Access Compliance Report

Public Rights-of-Way

(Curb Ramps)

Intersection ID: 5563	Main Street: N I-77 EXIT 16 RA	Cross Street: N/A	Location: SW
ADA ID: F7B78B076A5B	Ramp Type: Directional1	Initial Pass/Fail: Fail	Overall Compliance: No
Severity Score: 12.5			
Codes/Mitigation Info/Possible Solution		Field Measurements/Component Compliance

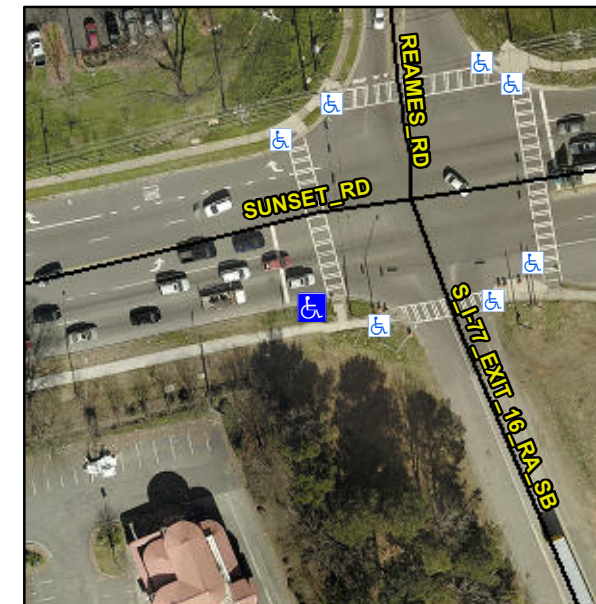
R304.2.2

Compliance	Description	Data	Compliance	Description	Data
N/A	Ramp Length (in)	85.0	N/A	Grade Break?	N/A
Yes	Ramp Width (in)	69.0	N/A	Grade Break Slope (%)	0.0
No	Ramp Slope (%)	8.5	N/A	Grade Break XSlope (%)	0.0
Yes	Ramp XSlope (%)	0.1			
N/A	Flare Type LT	N/A	N/A	Flare Type RT	N/A
N/A	Flare Slope LT (%)	N/A	N/A	Flare Slope RT (%)	0.0
N/A	Flare Traversable LT?	N/A	N/A	Flare Traversable RT?	N/A
N/A	Landing Length (in)	0.0	N/A	DWS Provided?	N/A
N/A	Landing Width (in)	0.0	N/A	DWS Contrast?	N/A
N/A	Landing Slope (%)	0.0	N/A	DWS Length (in)	N/A
N/A	Landing X Slope (%)	0.0	N/A	DWS Full Width?	N/A
N/A	Landing Curb? (Y/N)	N/A	N/A	DWS Offset LT (in)	N/A
N/A	Shared Landing?	N/A	N/A	DWS Offset RT (in)	N/A
N/A	Gutter Ponding?	0.0	N/A	Gutter Slope (%)	N/A
N/A	Gutter Lip Ht (in)	0.0	N/A	Gutter X Slope (%)	N/A
N/A	Painted X Walk1?	Yes		Road Slope (%)	0.0
	X Walk 1 Direction	To N		Road X Slope (%)	4.3
	X Walk 1 Width (in)	112.0		Clear Space?	N/A

Remove & Replace Entire Ramp.
